**CITY OF MAPLE RIDGE
BYLAW NO. 7810-2021**

TO: His Worship Mayor Dan Ruimy
and Members of Council
FROM: Chief Administrative Officer
SUBJECT: **Second Reading**
Zone Amending Bylaw No. 7810-2021
22582, 22588, 22596, 22606, and 22610 121 Avenue

MEETING DATE: September 12, 2023
FILE NO: 2021-471-RZ
MEETING: CoW

EDGE 4 CONDOMINIUMS

SHEET TITLE
BLDG ELEVATIONS
WEST AND NORTH

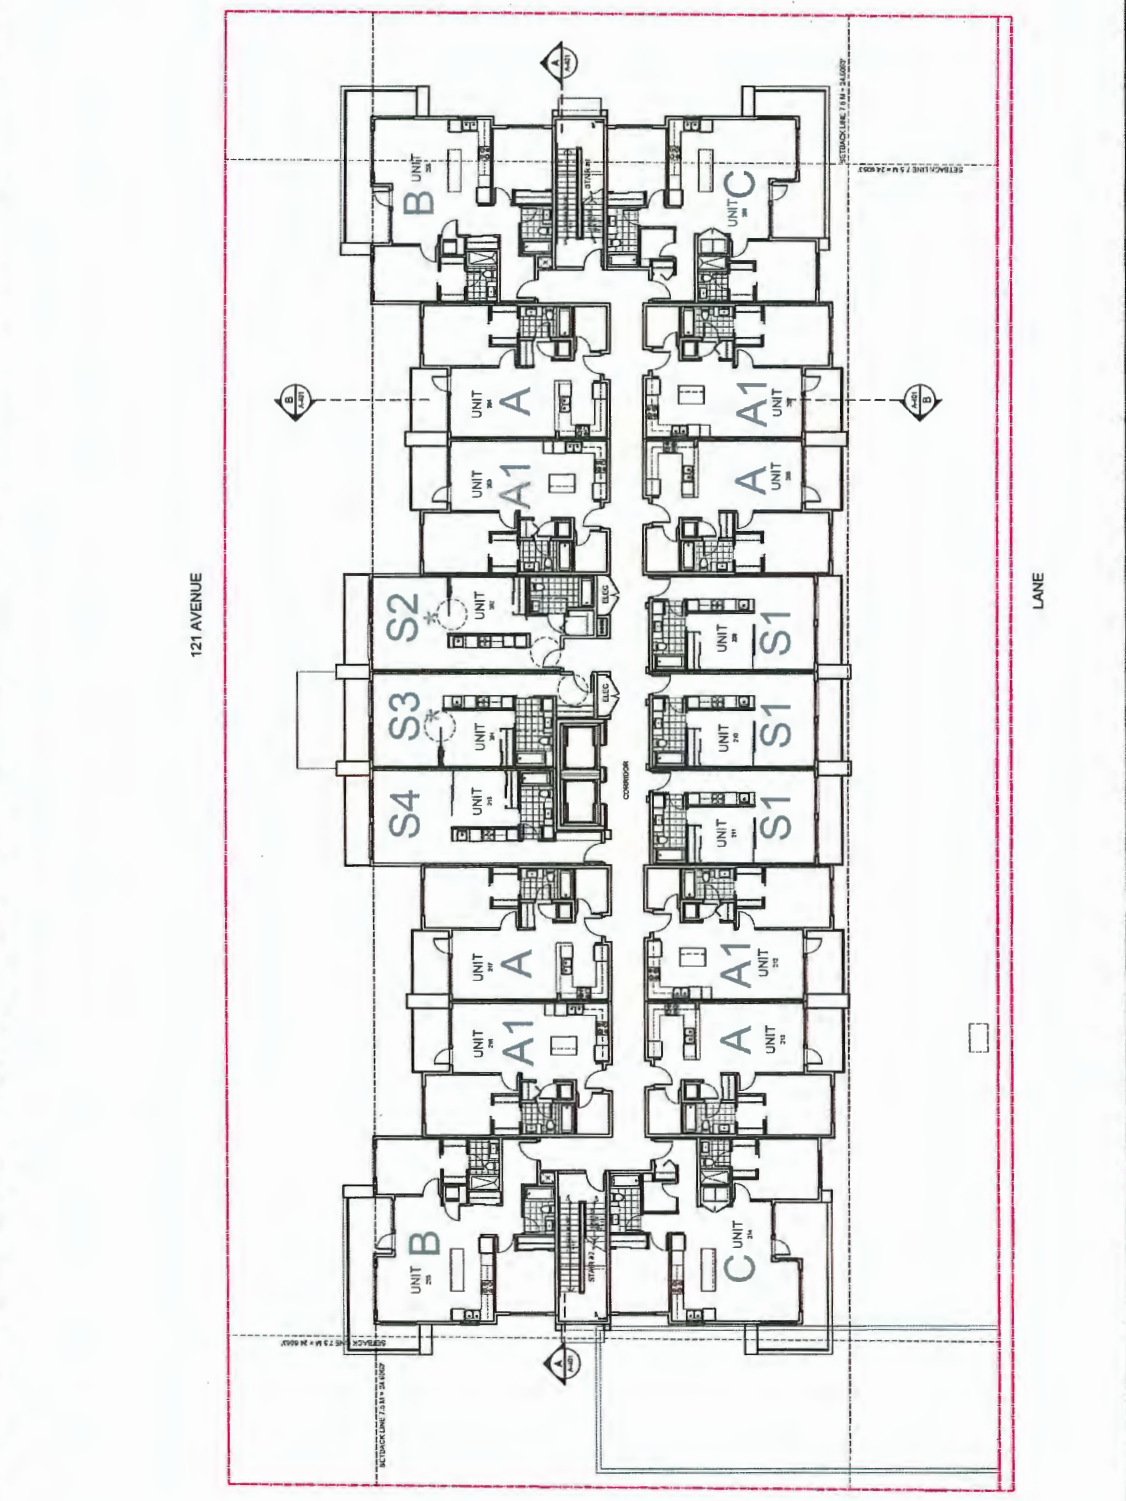
- Increase visibility of main entrance canopy by raising it taller.
(GZA) The entry to the building was highlighted by increasing the size of the covered space sheltering the entrance to the building. The new canopy reaches closer to the property line. We also increased the thickness of the canopy roof which will be highlighted by using a bright red color and additional lighting on the soffit. The height of the canopy will not be altered as its proportion is adequate for a five-storey building, in our opinion. Additional emphasis to this area was created with the revised landscape plan. Refer to pages A-0.01 and A-3-01 for revisions to the entry canopy.

MACLEAN HOMES
PRELIMINARY SECTION, DETAILS & PLANT LIST
PROJECT NO. 2022-12
DATE: JUNE 2022
DRAWN BY: JAC/JAC
CHECKED BY: JAC/JAC
DATE: JUNE 2022
SCALE: 1/8" = 1'-0" (SHEET)
SHEET NO. 13 OF 3

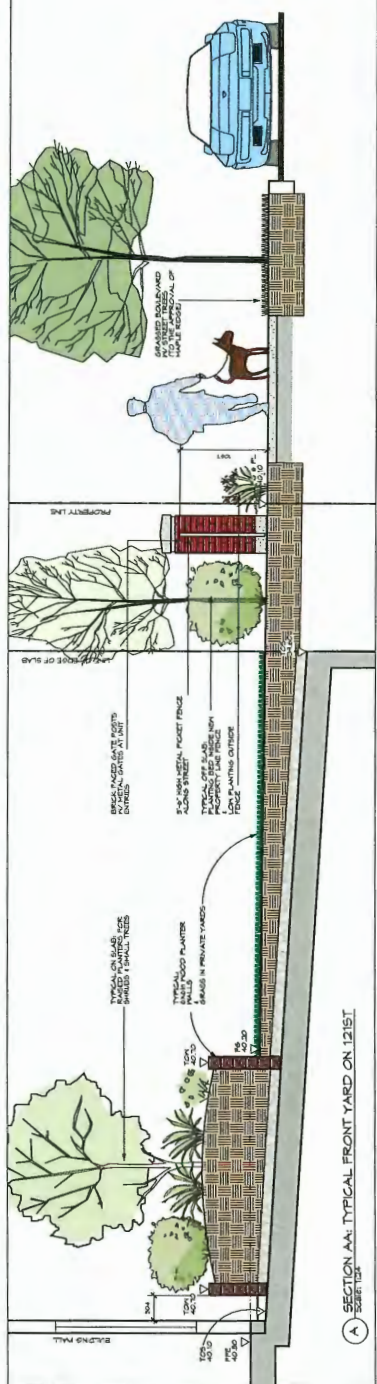
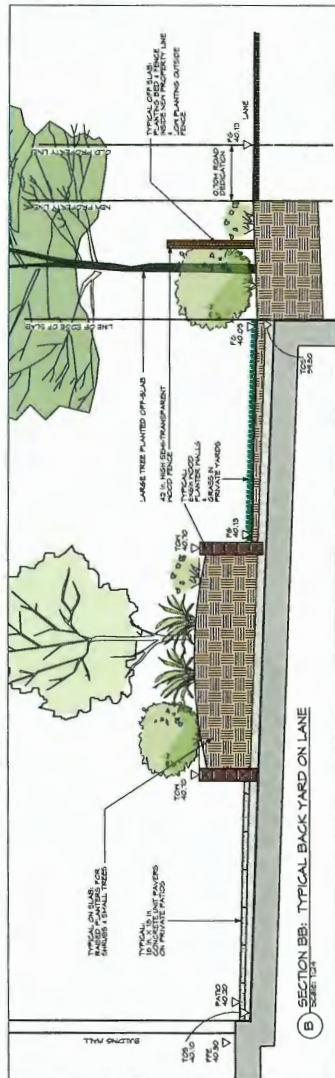
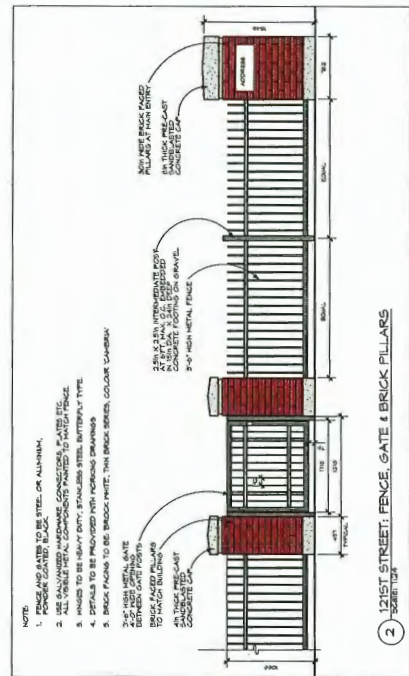
- Suggest access separation between outdoor amenity and public areas.
(VLA) We have redesigned the amenity area to include an 18in. high concrete planter along the east edge to separate it from the public entry. The planter will include either evergreen flowering shrubs +/-3ft high / total height 4.5ft, or a 4ft. hedge plus layered planting. Planting T.B.D. at detailed design stage.

- In the amenity area, there is a planter and seat wall – if you intend that to be a seat wall provide more space on the ledge.
(VLA) Seating ledge has been widened to 12 inches and extended as noted above.
